**Pacific Star Warehouse at St. Lucie West  
Major Site Plan Application  
(P06-391-A1)**

# Proposed Project

# Recommendation

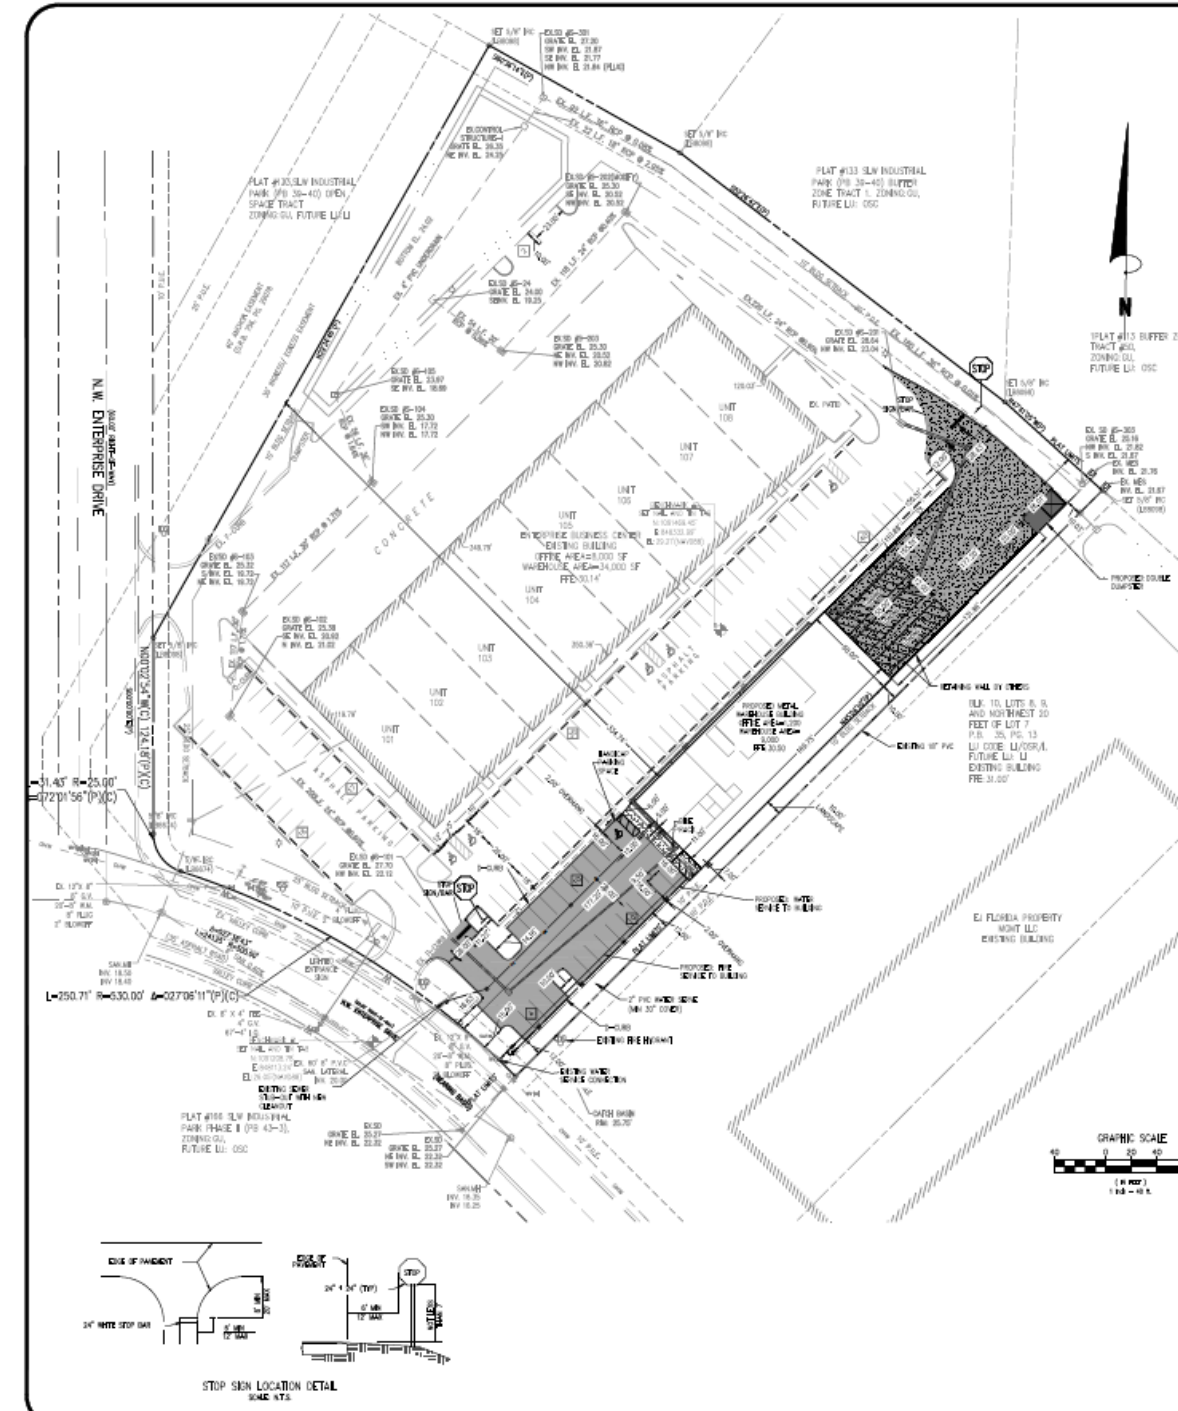
CRITERIA	FINDINGS
USE	The proposed use of warehouse building is compatible with the Industrial (IN) zoning designation.
DUMPSTER ENCLOSURE	The site plan provides for a 12 X 12 dumpster enclosure to accommodate refuse and recycling collection.
ARCHITECTURAL DESIGN STANDARDS	The applicant has provided documentation that the St. Lucie West Industrial Association has approved the elevation drawings and site plan.
STACKING REQUIREMENTS	A traffic analysis was provided and approved by the Public Works Department.
BUILDING HEIGHT	The proposed building height is 20 feet. Maximum allowed is 35 feet in Industrial Zoning District.
SETBACKS	Complies with the requirements of the Industrial Zoning District.
PARKING	134 parking spaces are required and 136 are proposed. Six handicap spaces are required and six are proposed.
BUFFER	The site plan depicts required ten- foot perimeter landscape buffer.
